# Tensioning arm 534 0325 10

## Improved markings

Part no.: 534 0325 10

Image 1: Tensioning arm 534 0325 10 – Left, old version with fixing screws M8x40. Right, new version with fixing screws M8x30.

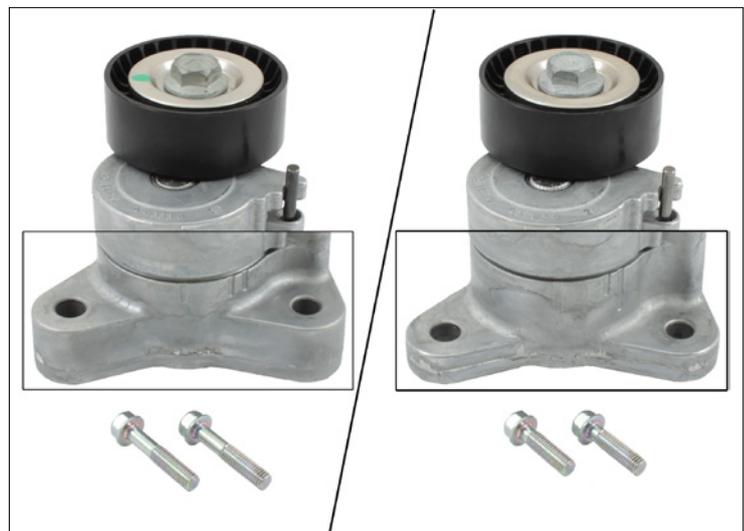
As part of our continuous efforts to improve our products, changes have been made to the tensioning arm 534 0325 10.

The working range marks (A1/A2, image 2) on the housing of the new tensioning arm have been made clearer and longer. This clarity makes it easier to check that the V-ribbed belt is correctly tensioned when the tensioning arm is installed.

When the V-ribbed belt is fitted and the locking pin is removed, the mark on the lever (M, image 2) must be in the area of the nominal position (N, image 2). When the engine is running, the mark on the lever moves between A1 and A2 in the working range (image 2).

Please note that the fixing screws supplied are shorter to match the thinner mounting flange (image 1).
